# UNITED STATES PATENT AND TRADEMARK OFFICE

APPLICATION NO.	FILING DATE	FIRST NAMED INVENTOR	ATTORNEY DOCKET NO.	CONFIRMATION NO.
10/675,088	09/30/2003	Jung-Seon Park	CU-3336 VE	4762

## Office Action Summary

## **DETAILED ACTION**

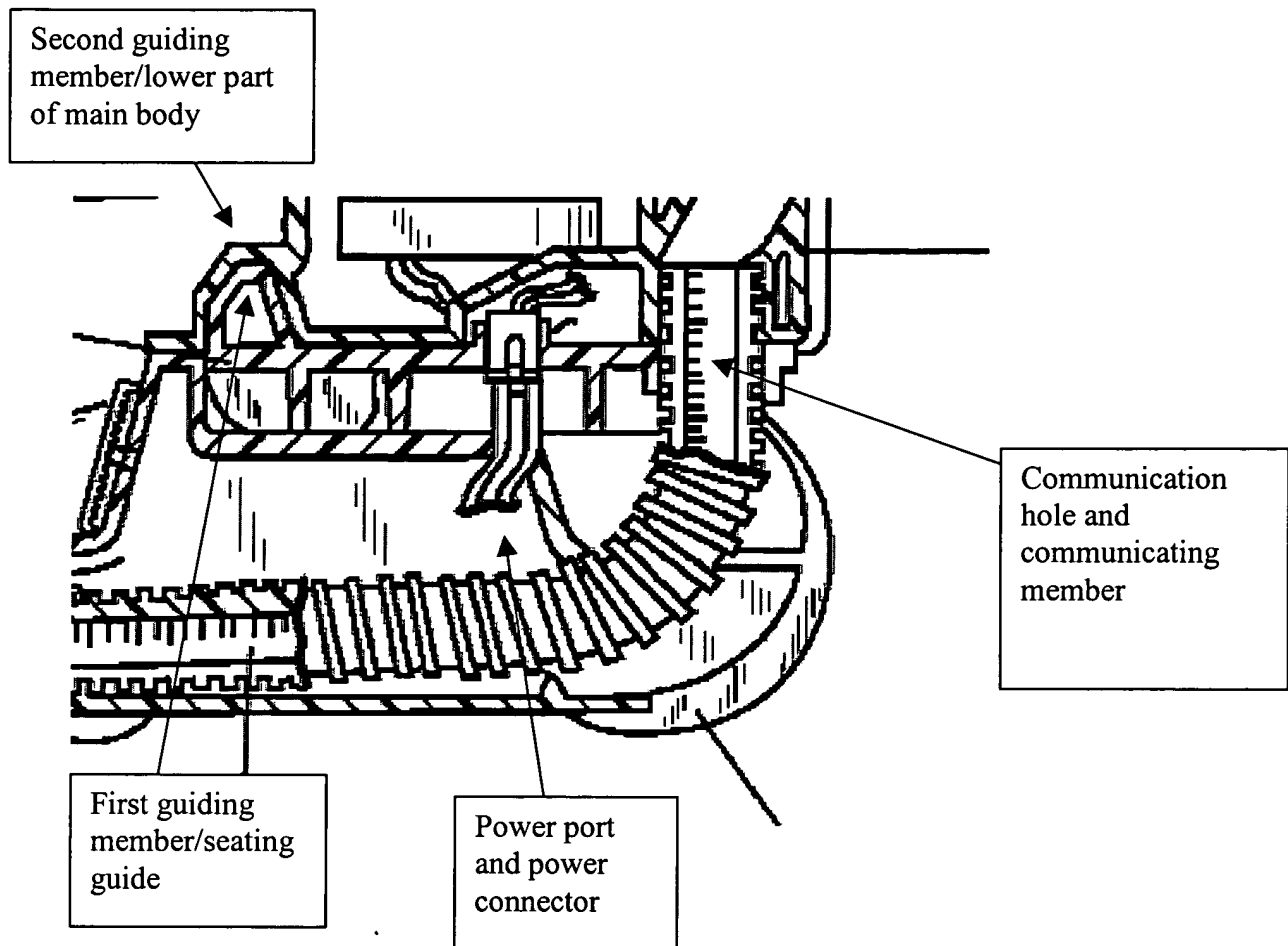
assembly is directed to the main body of the vacuum and a communicating member (94) connected to the communicating hole is formed at the main body of the vacuum (see figure below)

With regards to claim 11, there is a power port on one side of the connecting portion for providing power from the main body and a power connector disposed on the lower part of the main body to be connected to the power port (not labeled but shown on figure 6 to the left of the communication hole) (see figure below).

With regards to claim 12, there is a first guiding member on the connecting portion and a second guiding member corresponding to the first guiding member on the lower part of the main body (see figure below).

With regards to claim 13, the first guiding member is shaped in to a convex protrusion (cross section shows a convex shape in figure below) and the second guiding member is shaped in to a concave groove (cross section shows a concave groove in figure below).

With regards to claim 15, there is a seating guide on the connecting portion corresponding to the lower part of the main body of the vacuum cleaner (see figure below).

With regards to claim 16, the seating guide is shaped as a convex protrusion (cross section shows a convex shape in figure below) and the lower part of the main body is shaped as a concave groove (cross section shows a concave groove in figure below).
